DOCUMENT 00 90 00
ADDENDUM

ADDENDUM: 2

PROJECT: WESTERN TECHNICAL COLLEGE
SPARTA PUBLIC SAFETY TRAINING SIM CITY
11177 COUNTY HWY 1
SPARTA, WISCONSIN 54656
PROJECT NO. 25039

FROM: HSR Associates, Inc
100 Milwaukee Street
La Crosse, WI 54603
(608) 784-1830

1 1-OVERALL PLAN

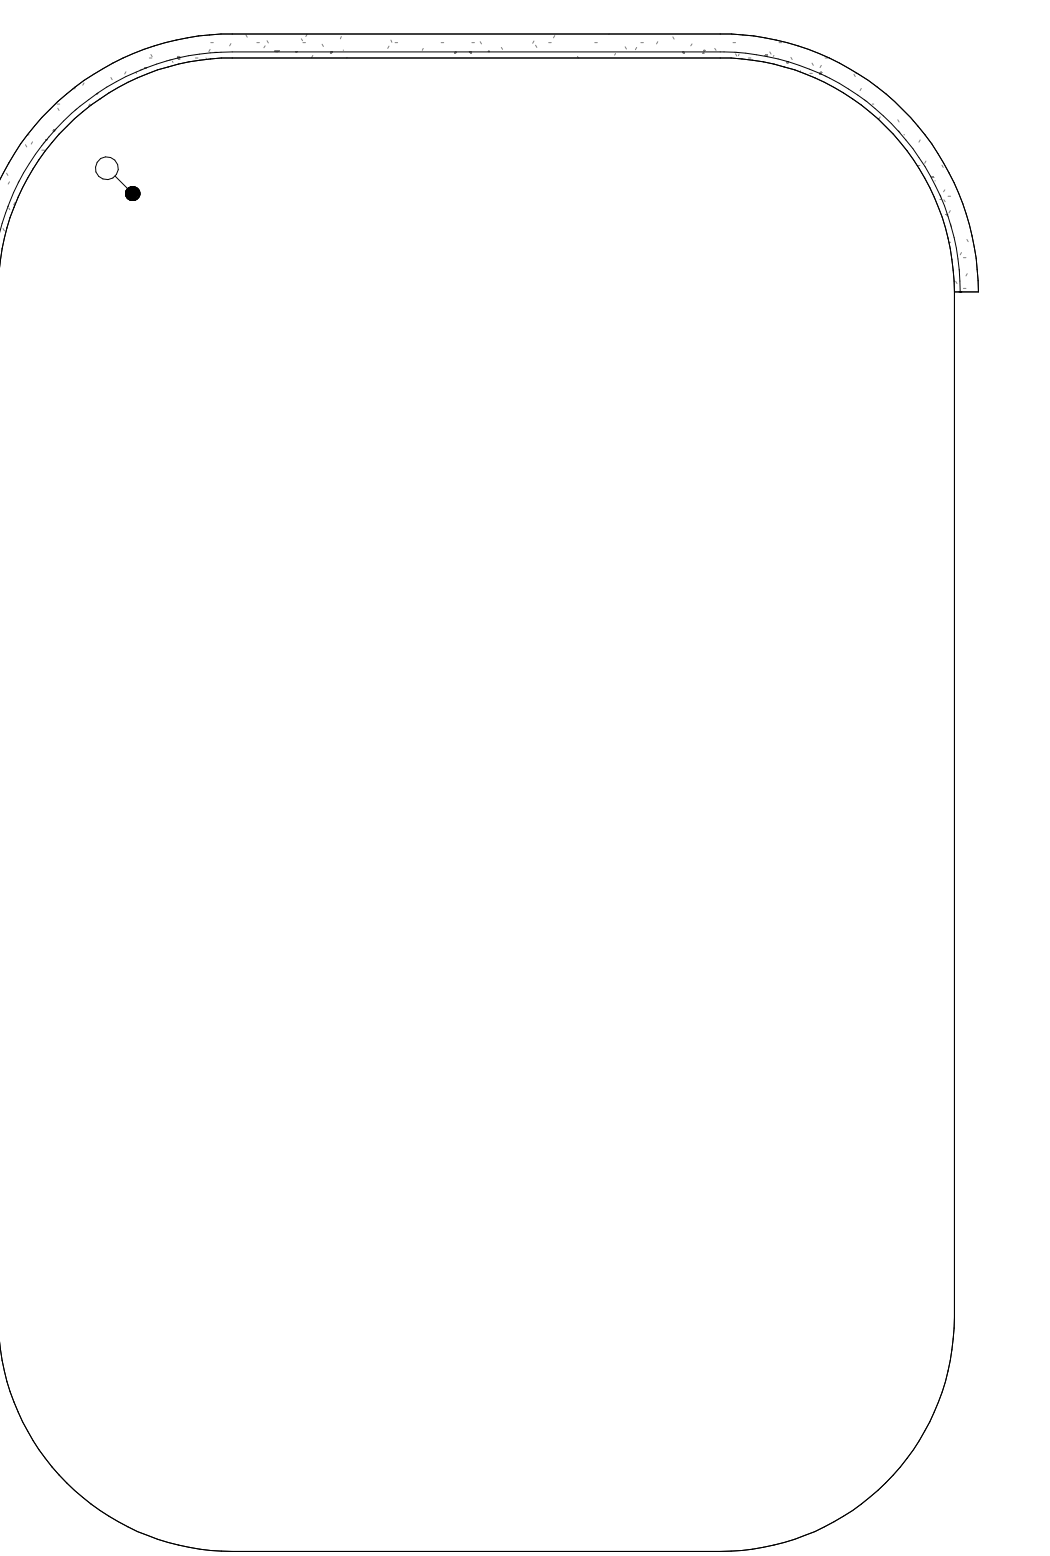
- a. See the revised sheet included in this addendum. Disregard the previous version.
 - b. Revised the location of the sectional door on commercial building B.

- c. Relocate associated items such as exterior lighting and bollards.
21. Sheet A101 FLOOR PLANS – RESIDENTIAL BUILDINGS 30"x42"
 - a. See the revised sheet included in this addendum. Disregard the previous version.

2 SIDE ELEVATION
1/4" = 1'-0"

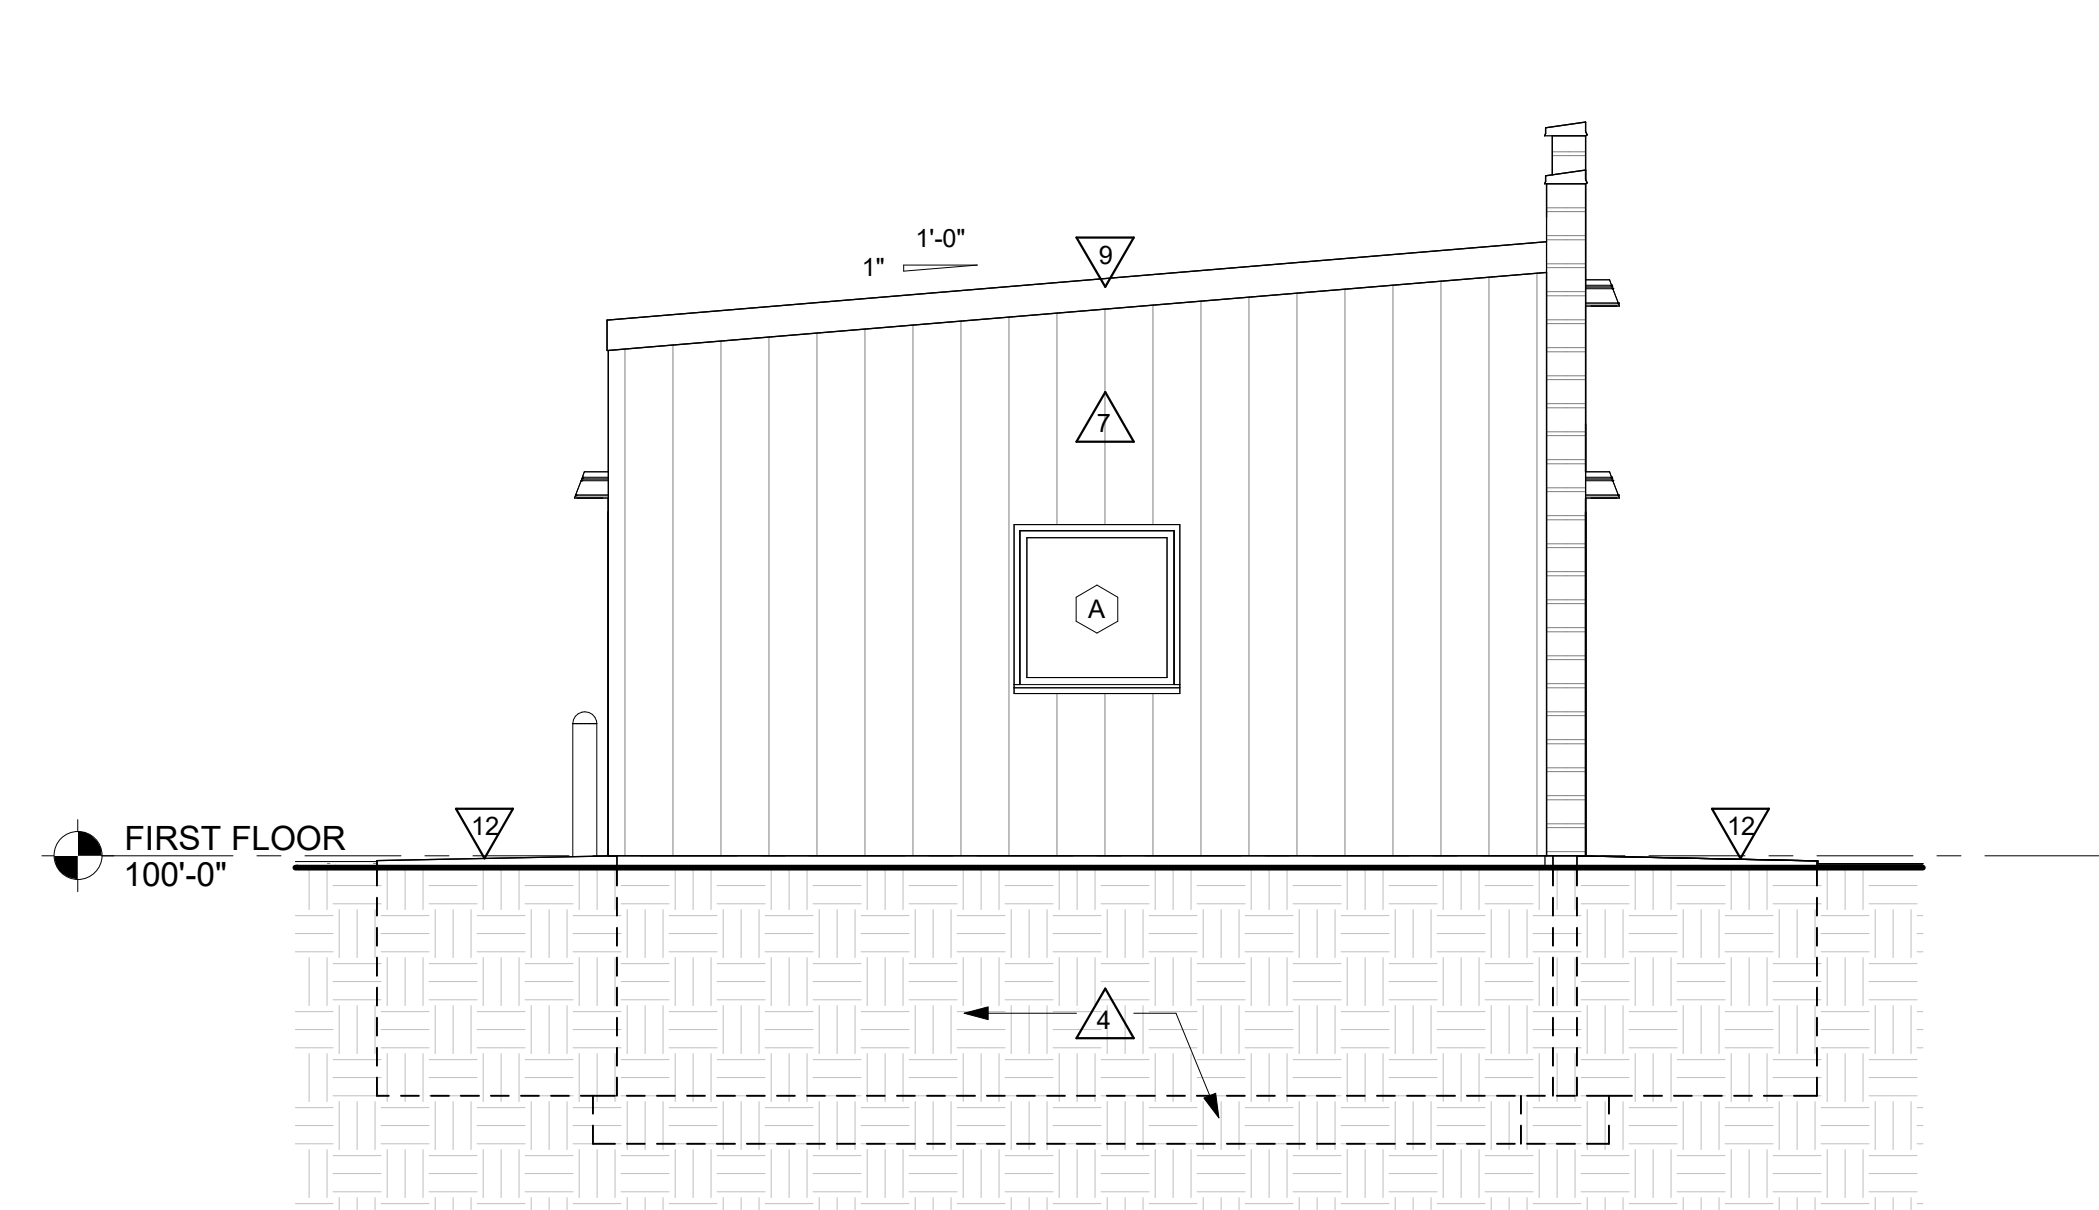
OVERHEAD DOOR TO BE ON END WALL OF COMMERCIAL BUILDING B

3 FRONT ELEVATION-BUILDING A
1/4" = 1'-0"

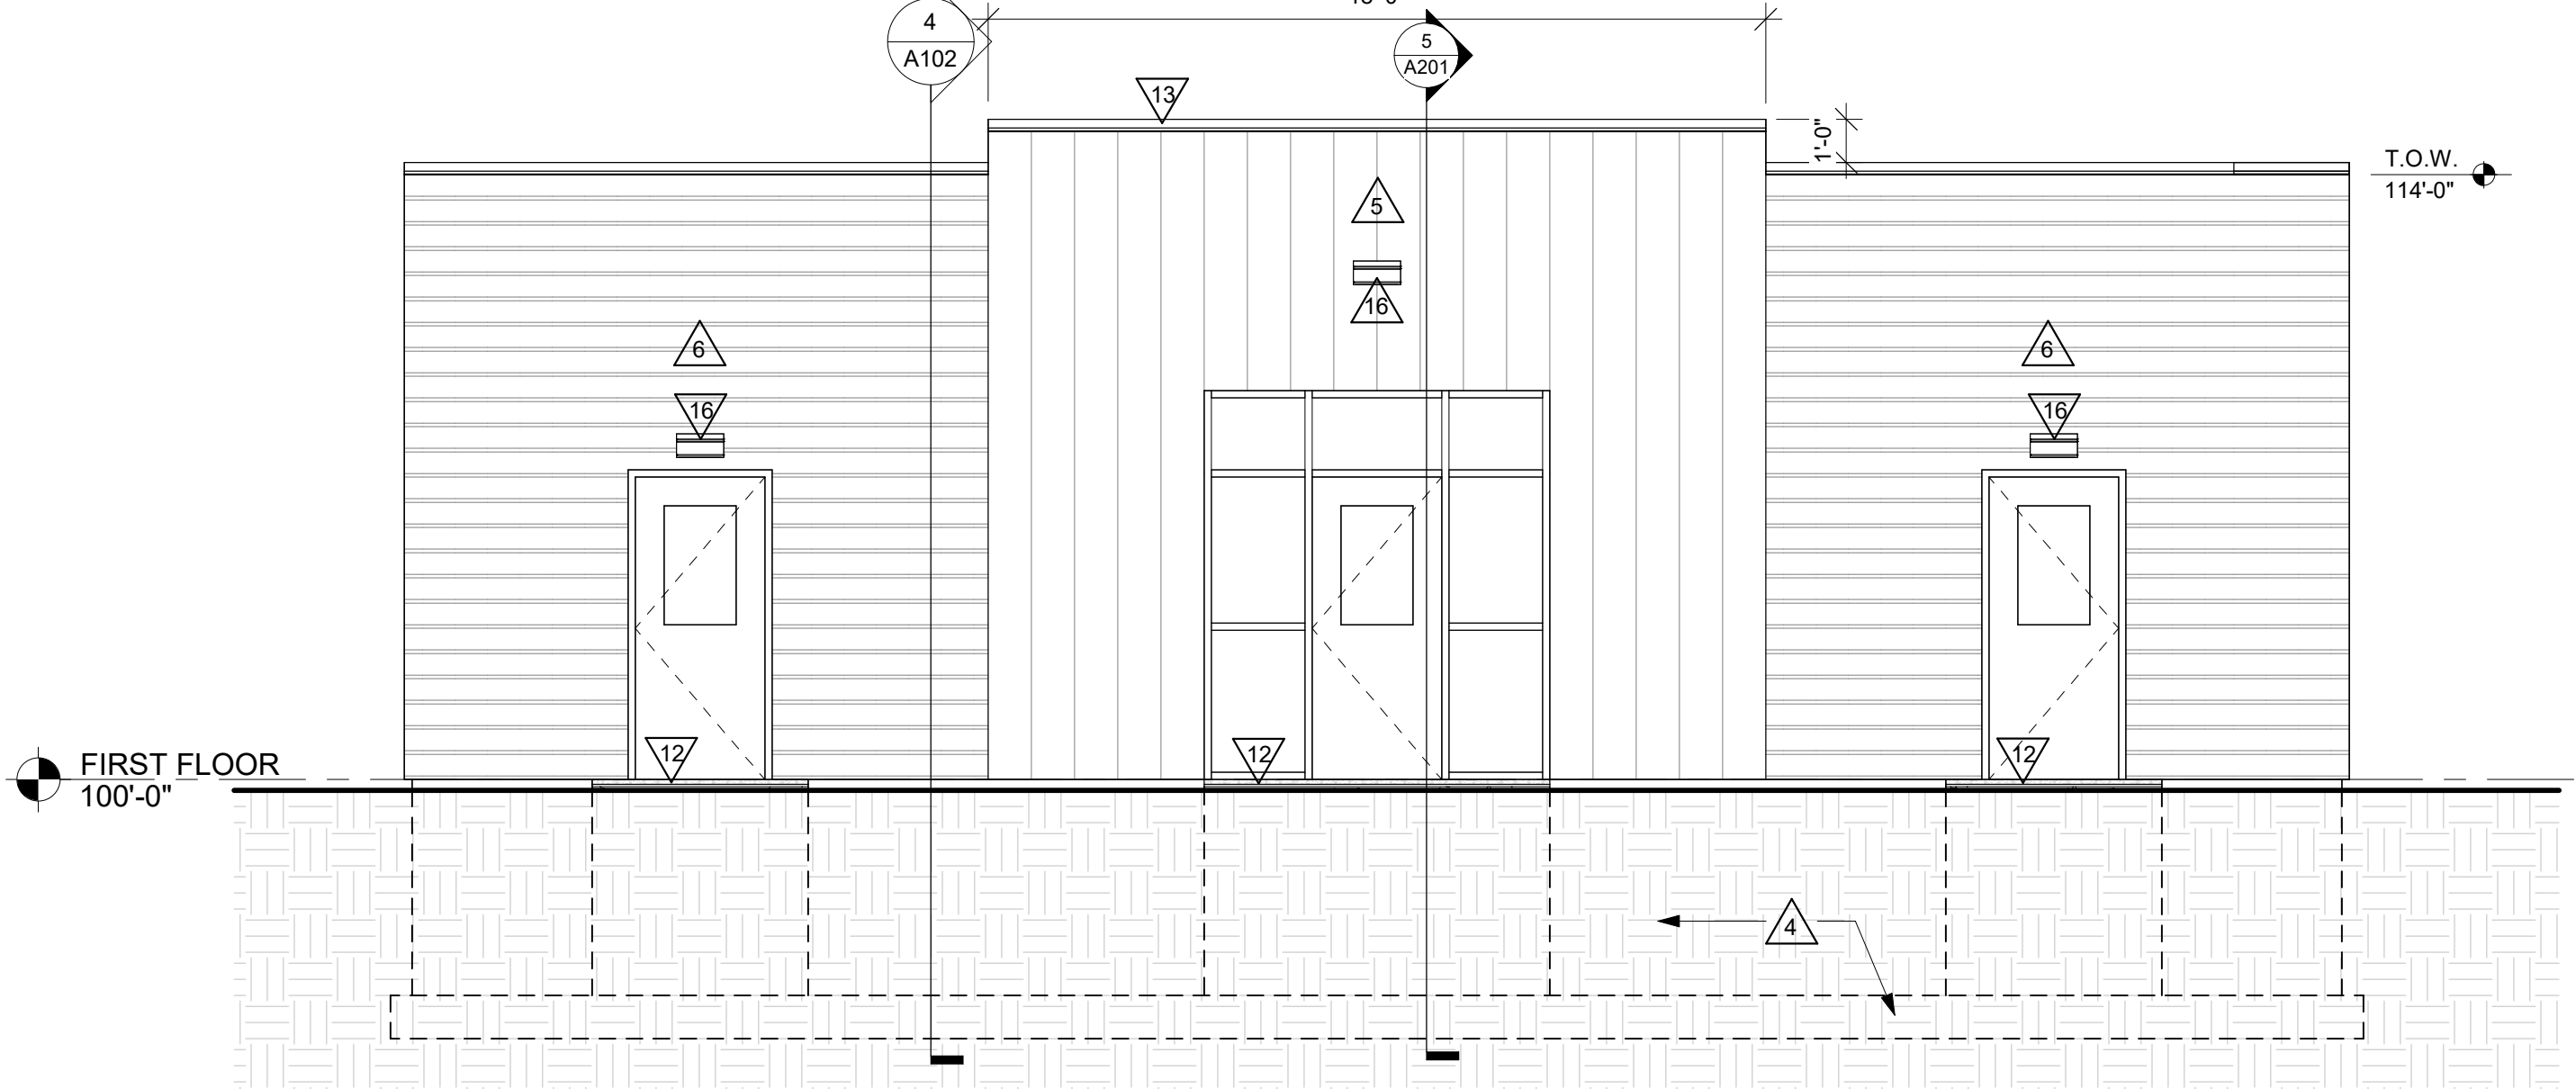
OMIT WINDOW, ADD OVERHEAD DOOR AT COMMERCIAL BUILDING B

5 BUILDING SECTION
1/4" = 1'-0"

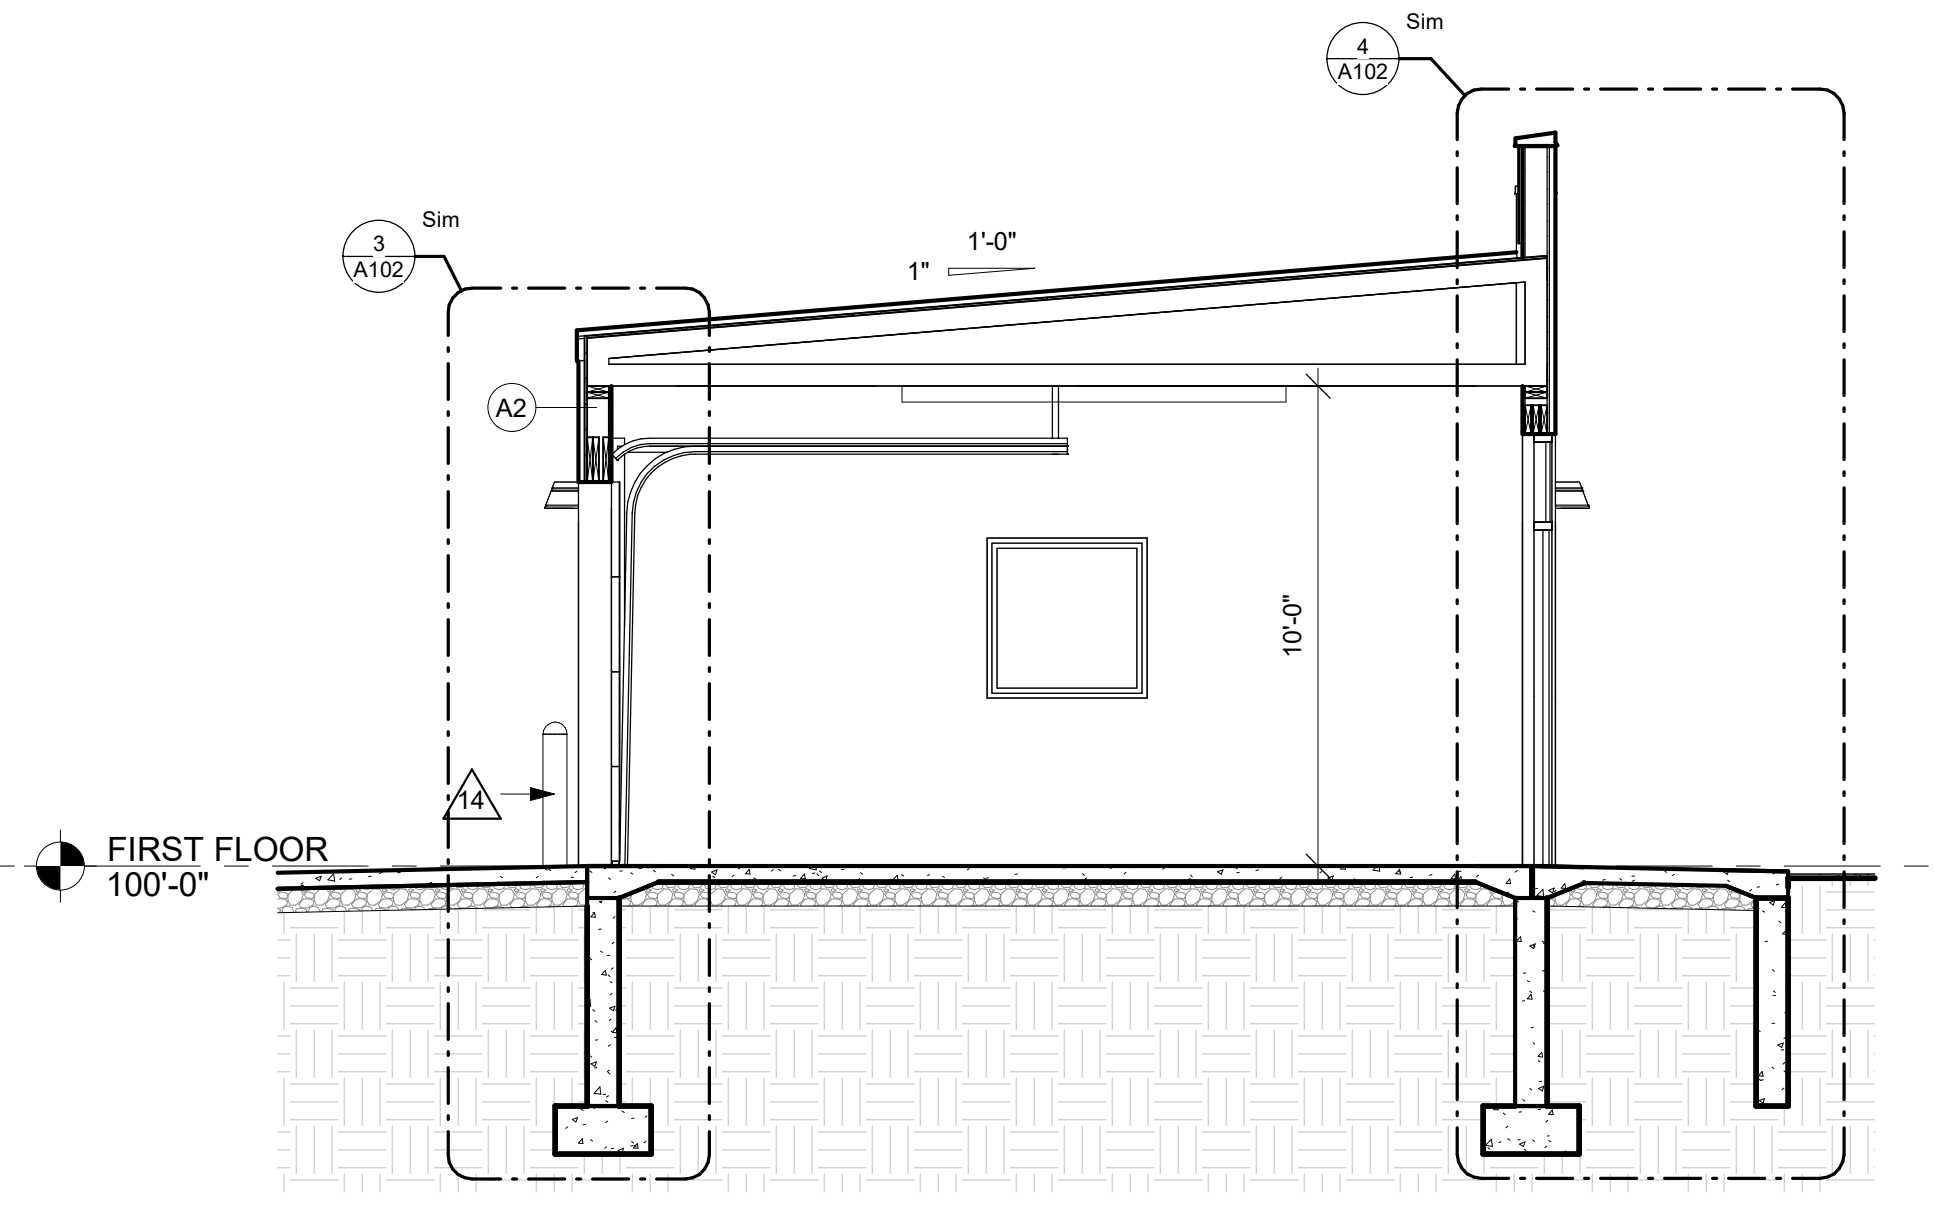
OMIT WINDOW AT COMMERCIAL BUILDING B
